Product News

NO.23
12E

Tank Top Type Filter Element (Former TTF Series) Notice of Discontinued Products

■Pressure Drop, Old vs. New

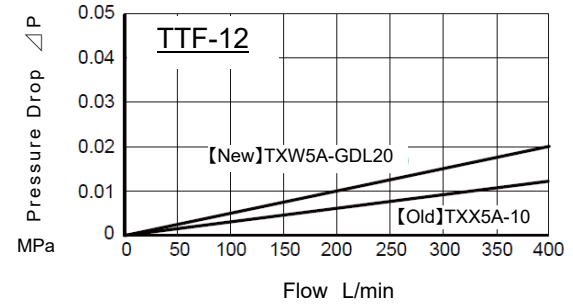
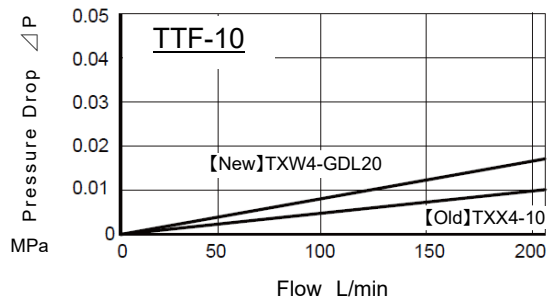
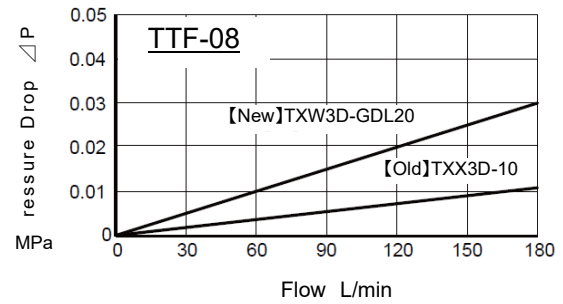
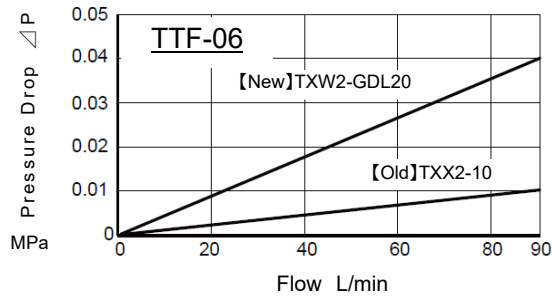
Filter body is the same and mounting dimensions are the same. Pressure drop is different according to the following graphs.

■Former products and alternative products (the alternative product is made of glass fiber filter paper and has absolute filtration rating of 20 μm).
